DUKE POWER COMPANY

Re: Oconee Nuclear Station
Docket Nos. 50-269, -270, -287

Pursuant to 10CFR50, §50.90 and in response to IE Bulletin 79.05B, Item 7, please find attached a proposed amendment to the Oconee Nuclear Station Facility Operating License. This request revises Oconee Nuclear Station Technical Specification 2.2, Safety Limit-Reactor Coolant System Pressure, and Specification 2.3, Limiting Safety System Settings, Protective Instrumentation.

OCONEE NUCLEAR STATION
PROPOSED TECHNICAL SPECIFICATION REVISION

OCONEE NUCLEAR STATION
Figure 2.3-1A

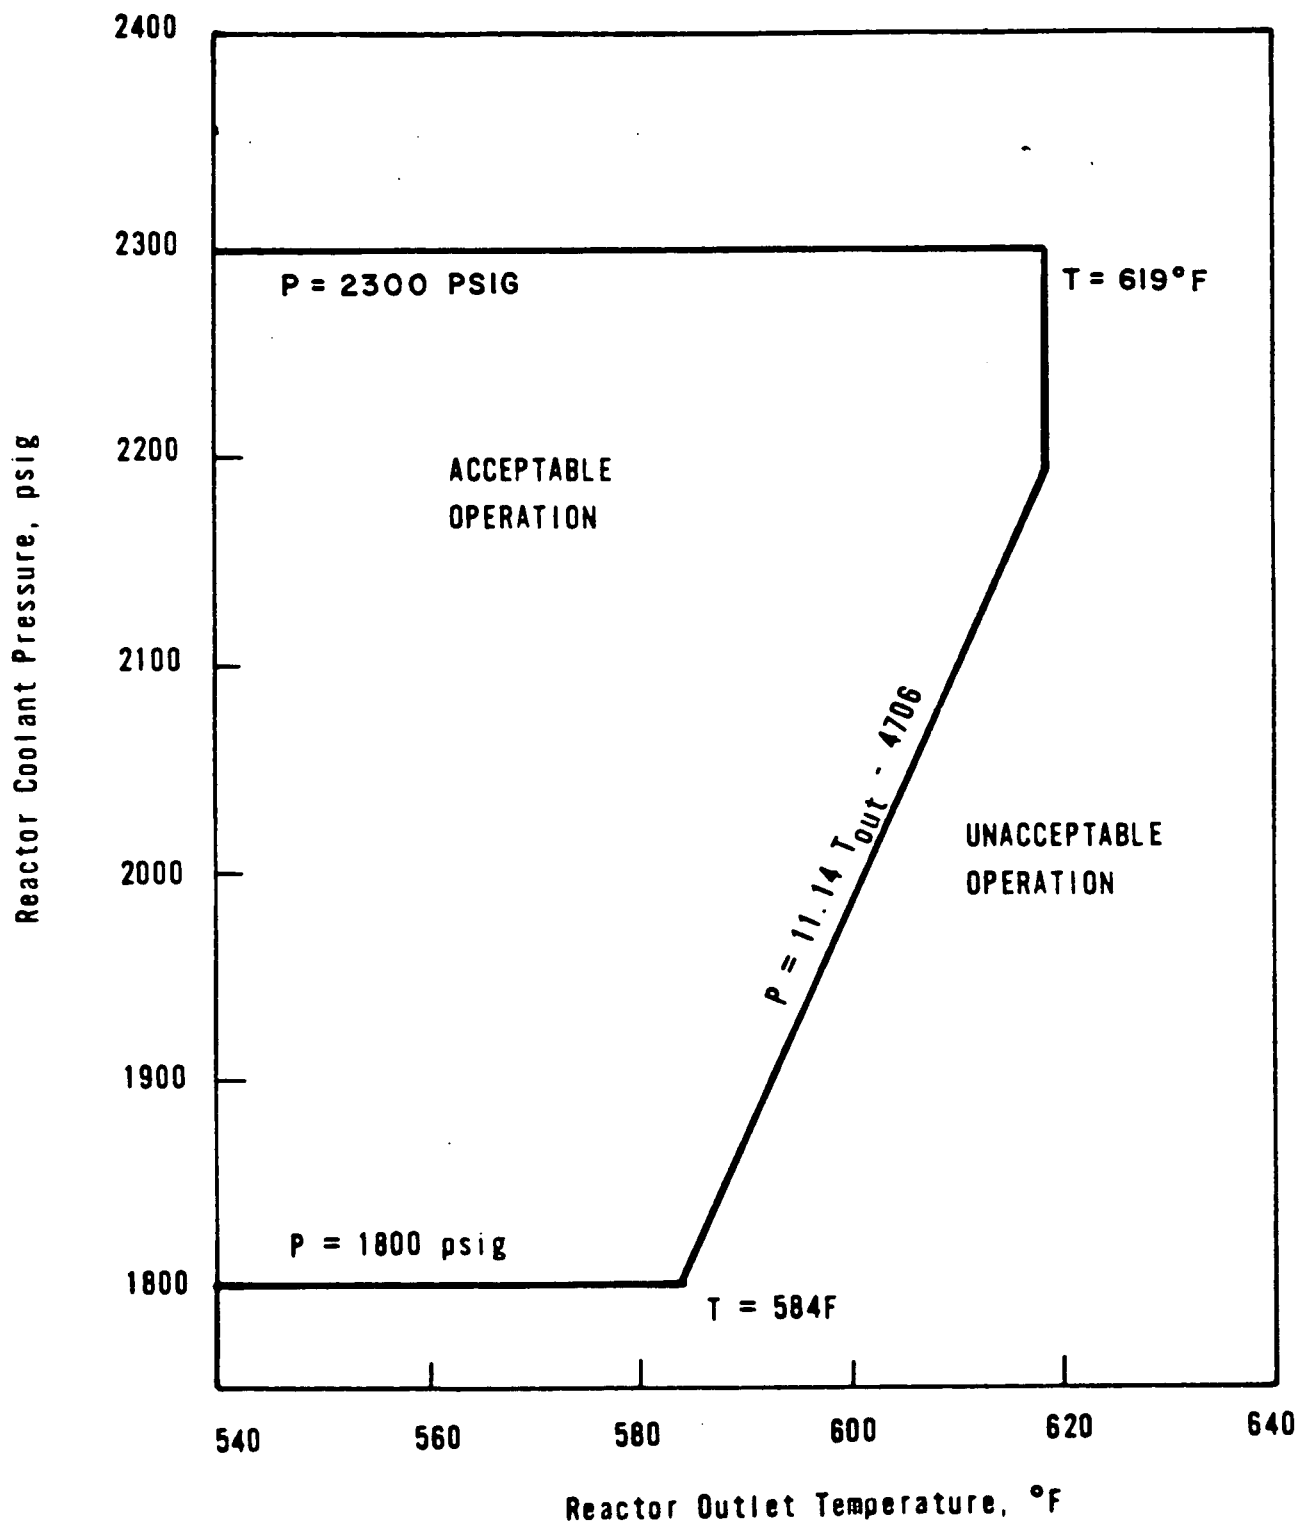
This proposed revision reflects recent changes to the setpoints of the pressurizer electromatic relief valve and the reactor coolant system high pressure trip made in response to IE Bulletin 79-05B.

During a startup accident from low power or a slow rod withdrawal from high power, the system high pressure set point is reached before the nuclear over-power trip set point. The trip setting limit shown in Figure 2.3-1A - Unit 1

for high reactor coolant system pressure (2300 psig) has been established to maintain the system pressure below the safety limit (2750 psig) for any design transient. (1)

Figure 2.3-1B

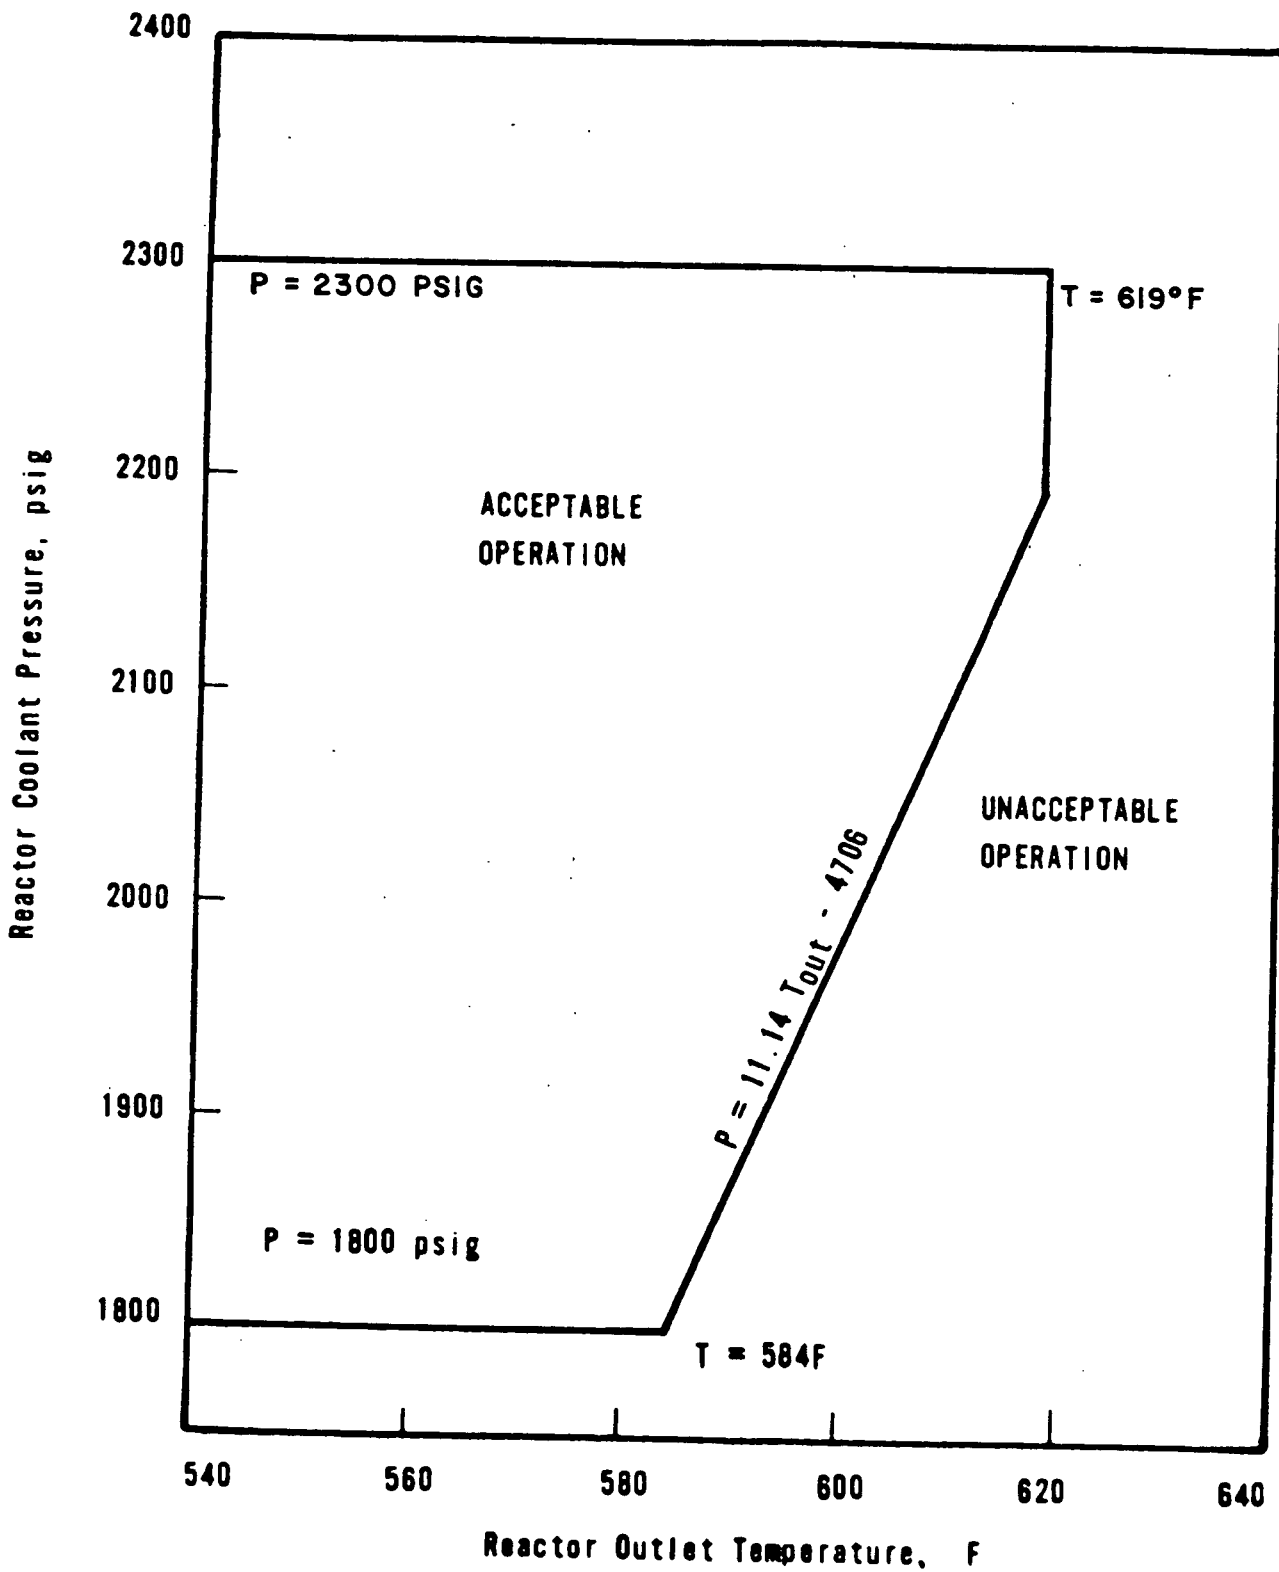
- 2.3-1B - Unit 2
- 2.3-1C - Unit 3
